# A12 Chelmsford to A120 widening scheme

# DEVELOPMENT CONSENT ORDER CHANGE APPLICATION CONSULTATION

# **B1023 Roundabout Technical Note**

Plate 1.1 Inworth Road Roundabout with Segregated Left Turn Lane as submitted for DCO Application

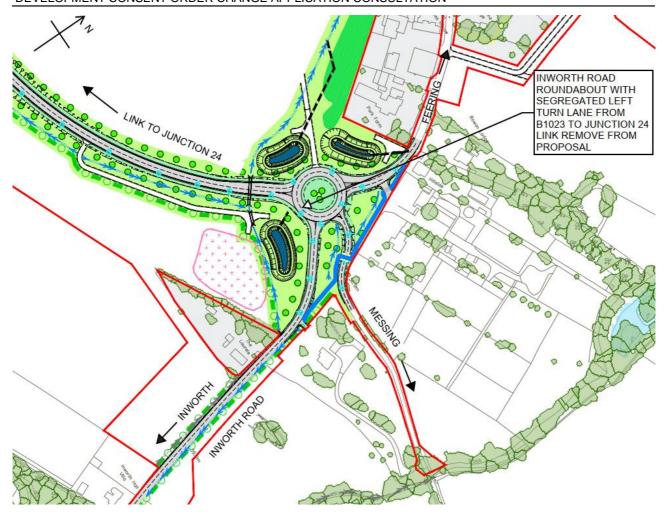
1.2.1 National Highways is proposing the removal of the segregated left turn lane (SLTL) from the arrangement of the Inworth Road Roundabout that was presented in the DCO application.

- 1.3.1 This SLTL was proposed to alleviate the potential queuing of traffic wishing to turn left from the B1023 south of the roundabout, by removing the conflict of this movement with drivers wishing to turn right at the roundabout from the B1023 north of the roundabout.
- 1.3.2 Through design refinement in the parallel detailed design process and validation against the strategic traffic model presented as part of the DCO

Application, its inclusion is not required for the roundabout to perform acceptably in the proposed scheme's design year of 2042. Further to this, the proposed removal of the SLTL helps reinforce the local nature of the existing B1023 in this area, reduces the area of impermeable pavement and therefore the drainage burden in the immediate vicinity.

2.1.1 The overarching design principle for this change was to ensure that the roundabout could operate safely and provide capacity for the forecasted traffic demand. An arrangement without the SLTL was drawn up and modelled in microsimulation software, the results are presented in section 3.3 below.
